TECHNICAL MEMORANDUM NO. 1 TO FINAL PHASE I RFI/RI WORK PLAN

VADOSE ZONE INVESTIGATION

SOLAR EVAPORATION PONDS
(OPERABLE UNIT NO. 4)

U.S. DEPARTMENT OF ENERGY
Rocky Flats Plant
Golden, Colorado

FIGURE 2-1
TECHNICAL APPROACH
CHARACTERIZATION ELEMENTS
SOLAR PONDS - OU4

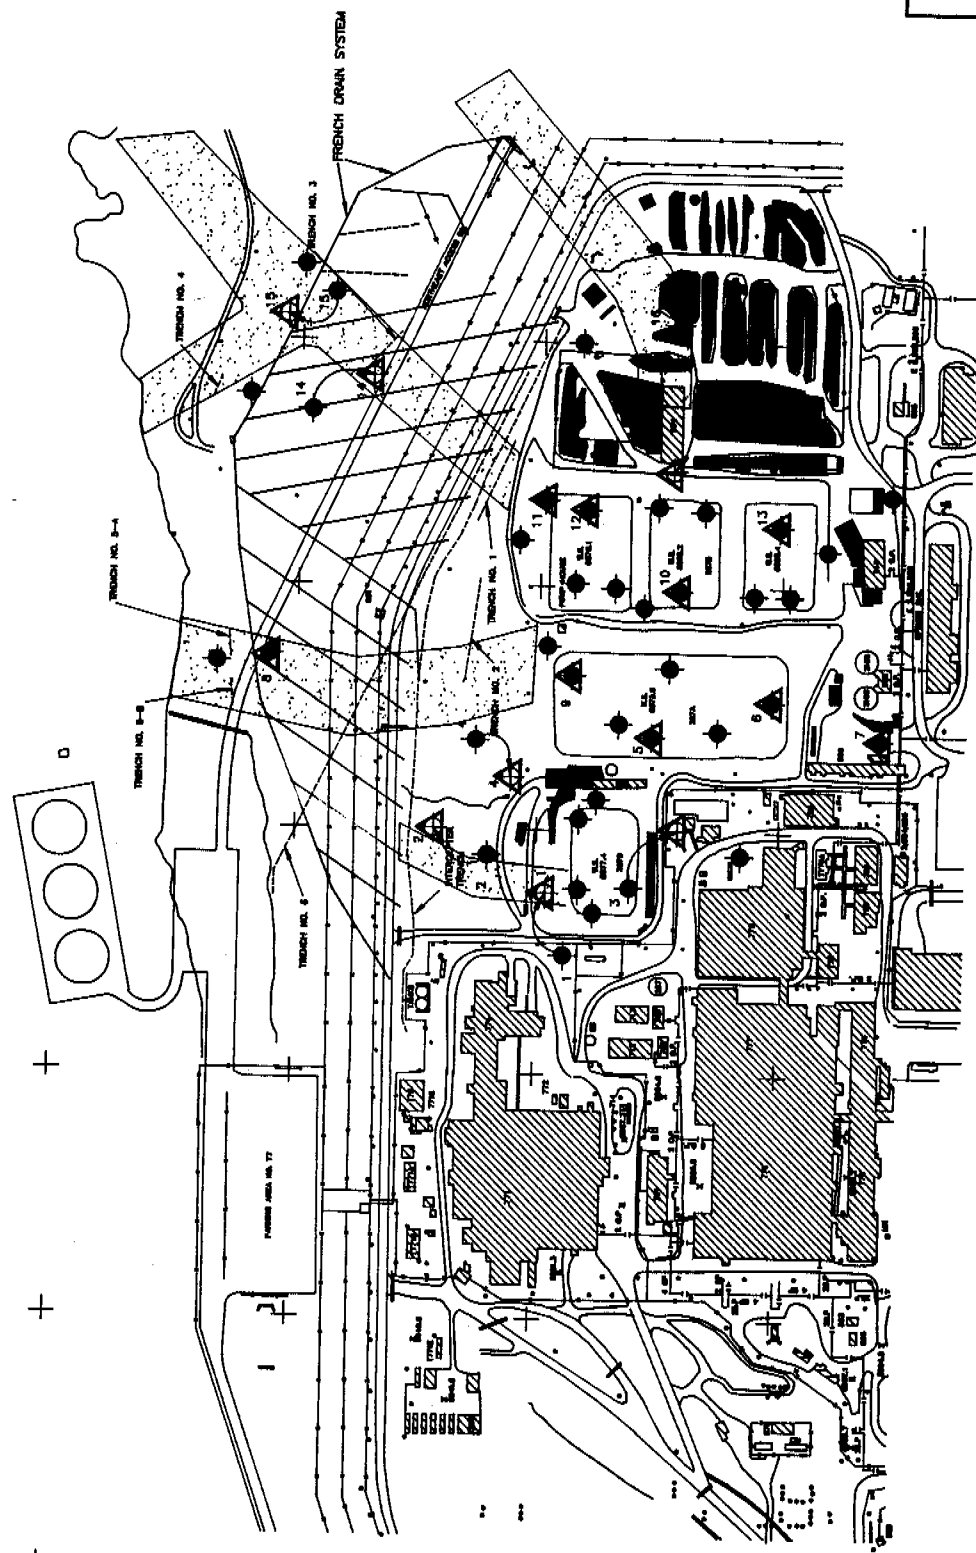
COMMENT 15: Figure 2-1: Work Element 4 is a decision point to determine whether enough data has been obtained to proceed with Work Elements 10 through 15. Section 2.2 does not discuss how this decision will be made. Ultimately, the adequacy of the data and conclusions will be decided by EPA and the Division upon delivery of the RFI/RI Report; however, an interim decision by DOE on when enough data is available to calculate Water Balance, for example, should be determined early on to minimize the need for a second round of data collection. The decision ideally should be made while the work is "in the field" rather than when DOE begins to run calculations and draw conclusions. Please discuss Work Element 4 in Section 2.2 to show how and when this decision will be made.

FIGURE 2-2
PRELIMINARY LOCATIONS
OF SOIL BORINGS
SOLAR PONDS - OU4

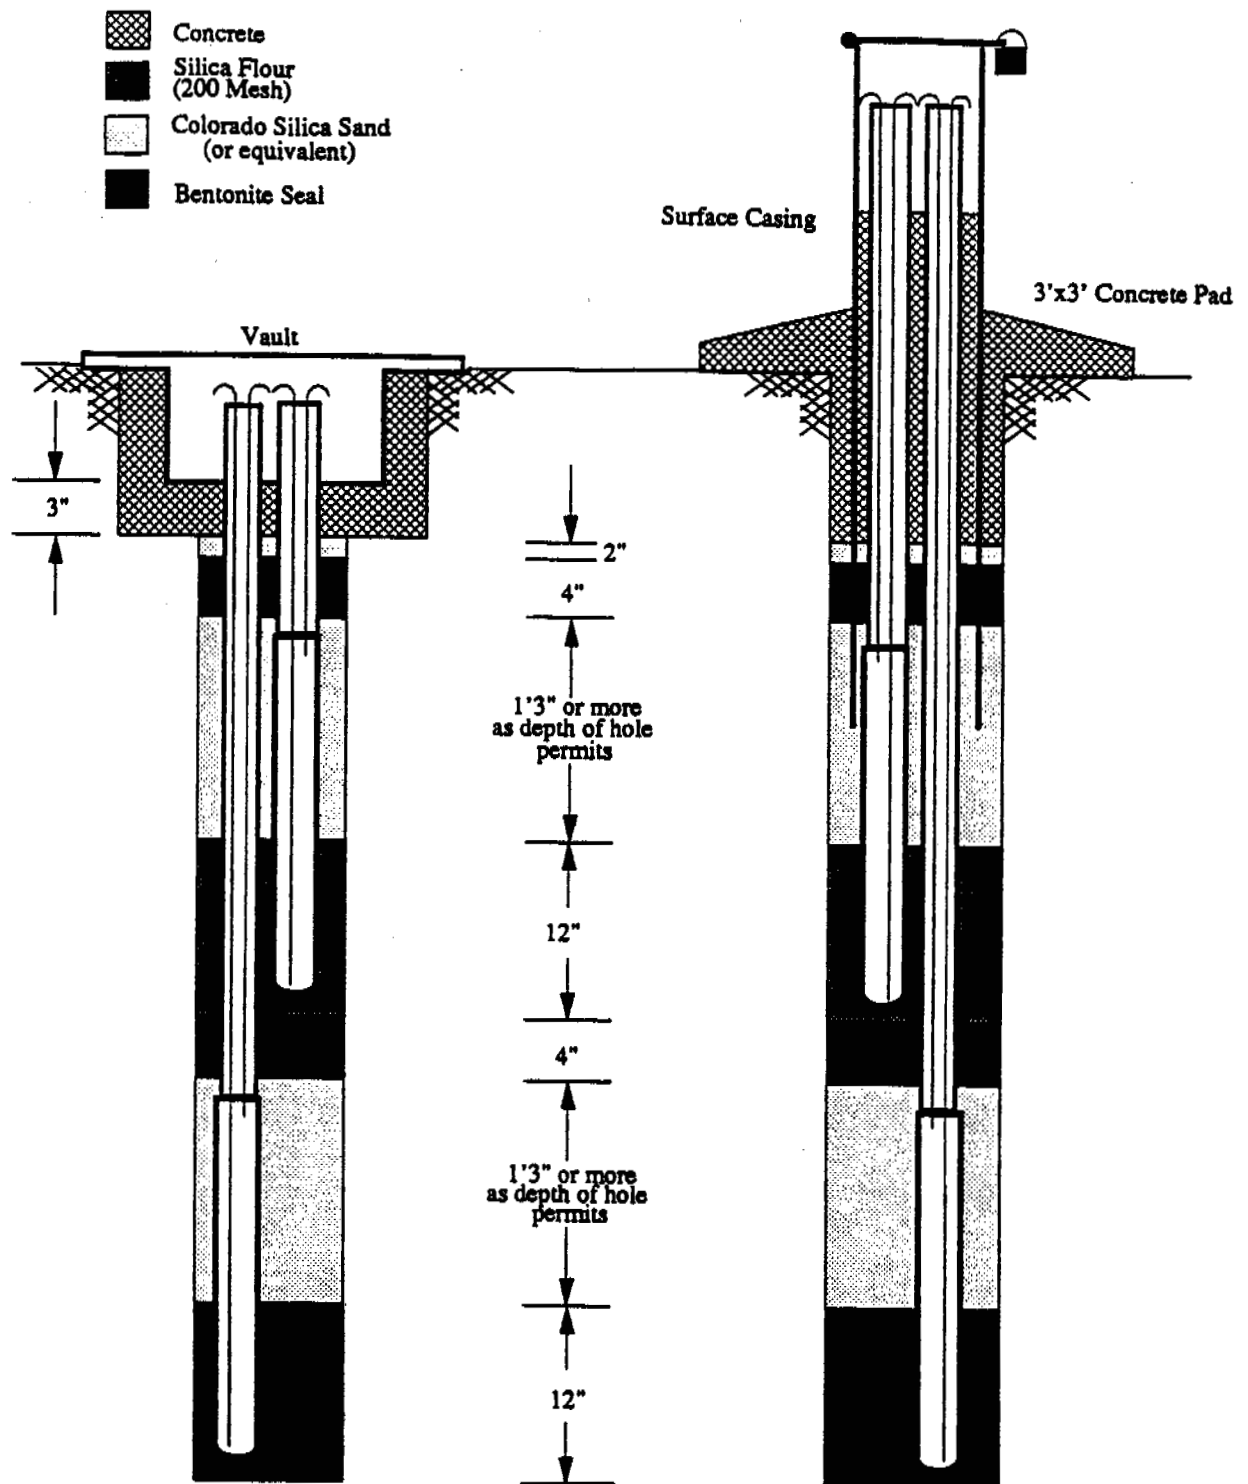
COMMENT 1e. Three areas of OU1 have been chosen for the soil gas survey. Two of the areas, original earthen ponds and upgradient area are not illustrated on Figure 2-2. These areas should be shown so that sample location choice can be verified.

Figure 2-2. This figure illustrates the locations of the vadose zone investigations. However, none of the 25 Guelph permeameter locations are illustrated and 2 of the double ring infiltrometer locations are. This does not make sense because double ring infiltrometer locations will be based on the Guelph permeameter results. Figure 2-2 should be corrected to show Guelph permeameter rather than double ring infiltrometer locations.

RESPONSE Areas attributed to the soil gas investigation at the original earthen ponds, 207B-series ponds, and upgradient area are indicated in Figure 2-4 of the final TM, which also identifies the proposed soil gas sampling locations.
